**Project #23-047
Cache Valley Marketplace
Located at approximately 1300 North Main**

Project Name: Cache Valley Marketplace
Proponent / Owner: Mitch Hohlen / Cache Valley Realty LLC
Project Address: 1300 North Main Street
Request: Design Review, Subdivision, Code Amendment, Rezone
Current Zoning: Commercial (COM)
Type of Action: Quasi-Judicial & Legislative
Hearing Date: July 13, 2023
Submitted By: Russ Holley, Senior Planner

RECOMMENDATION

Figure 1 shows the proposed site plan

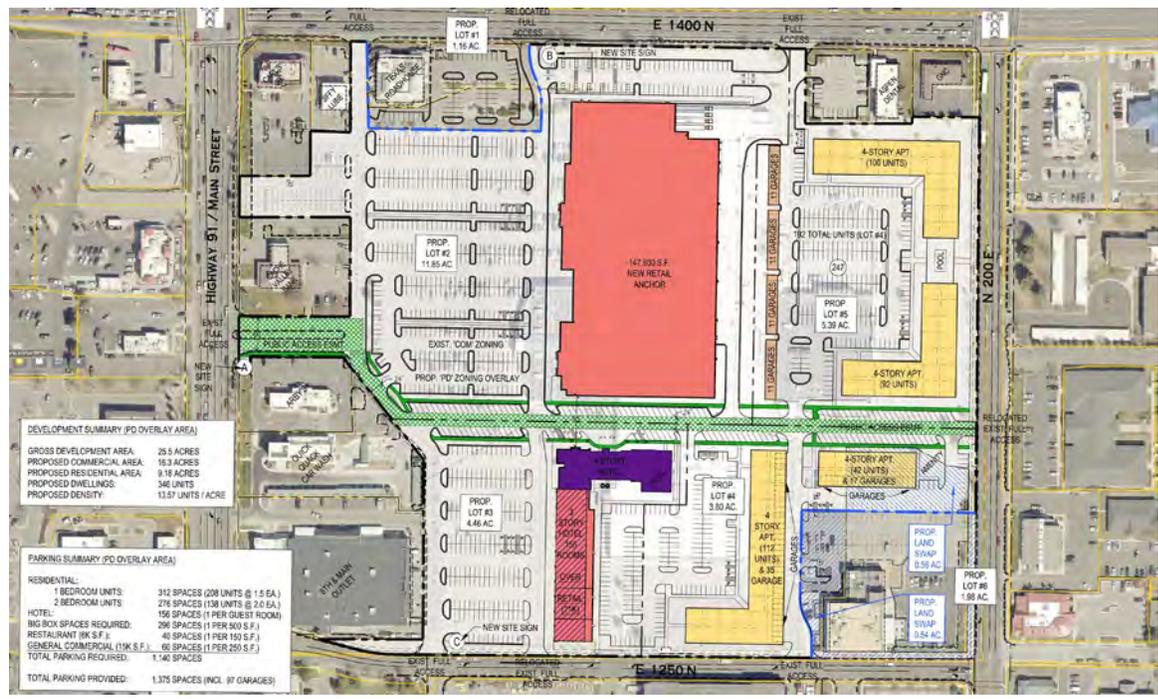
The proposed project complies with setbacks except for the proposed multi-family buildings which are shown at approximately 58' tall (mid-gable) and the hotel building is shown at 52' tall, and both are shown with front setbacks of less than 40'. The PD Overlay is being proposed to modify these height and setback regulations to allow for the project layout and heights as designed.

The LDC 17.30 require projects to provide pedestrian and street connectivity. The proposed site layout places the building near the sidewalk edge making walking quick and convenient. Some areas in the site lack direct and safe pedestrian networks and crossings. As conditioned with sidewalk connections and walkability throughout the site, including to adjacent bus stop locations, the project meets the requirements in the LDC.

13. Multiple landscaping areas shown shall be consolidated and combined to create a larger and more meaningful landscaped/useable outdoor space near the multi-family buildings.

10. The project shall provide a bus stop amenity along Main Street (Green and Blue Line) and a continuous pedestrian way with sidewalks and painted raised crossings to both the big box and retail buildings and the 200 East bus stops.

11. A raised painted crossing shall be installed between the west side of the big box and the west side of the retail building. Additional sidewalks shall be installed so that all multi-family units can walk on either a sidewalk or painted crossing to the big-box and hotel/retail building.

PROPOSED
E 1400 N
GROUND SIGN

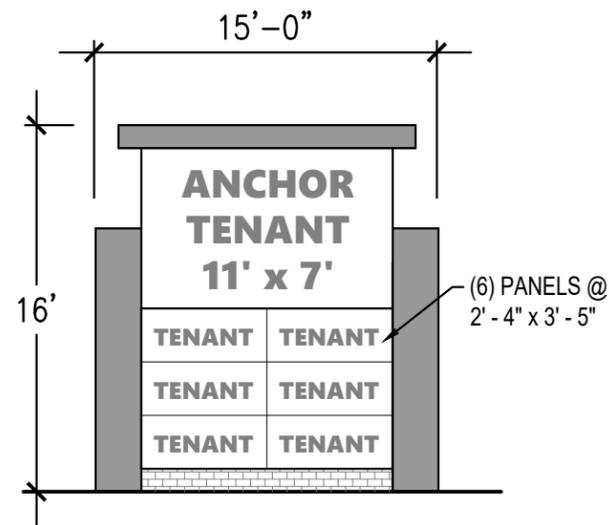
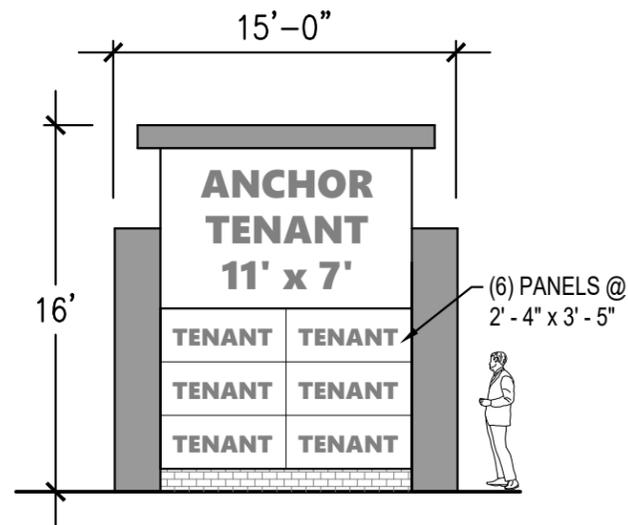
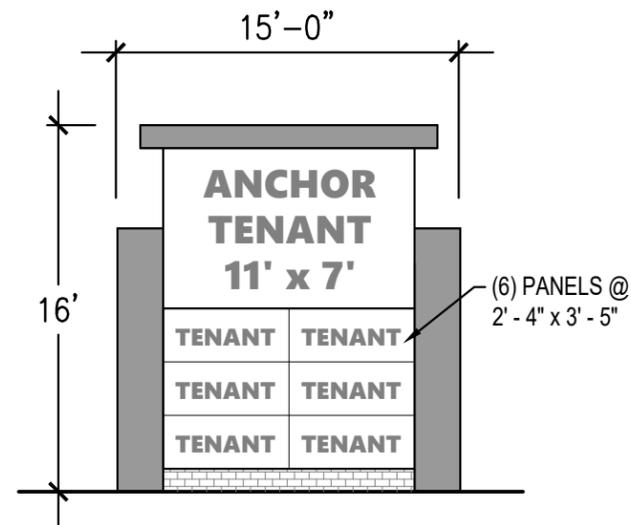
The LDC 17.33 allows different sign types and sign sizes based on street frontage and building size. Based on street frontages and property width, the project would be allowed up to six (6) monument signs at eight feet tall and 72 SF in size. As per the development plan request, the applicant is proposing three signs at 16 feet tall and 15 feet wide (double the standard) with one on each frontage (1400 N, Main, 1250 N). Staff is recommending that the City consider approving a slightly larger sign size than what is permitted in the code for a reduced number of signs and views this as a reasonable tradeoff and appropriate to the overall size and scale of the project. Staff is recommending that the project be entitled to three eleven-foot-tall signs with 108 SF, one for each of the three frontages, and one standard sized monument sign on 200 East rather than a total of six signs. Building signage would remain as permitted in the LDC for commercial and multi-family development types. The signage allowance will need to be adopted within the PD Overlay if anything different than standard sign code allowances are given. As conditioned, the project meets the requirements in the LDC.

12. The signage plan is approved to allow three monument signs not to exceed 11 feet in height and containing 108 SF of signage size, with one located along 1400 North, Main Street, and 1250 North, and a fourth monument sign to be permitted along 200 East provided it meets the minimum sign requirement in LDC 17.33.
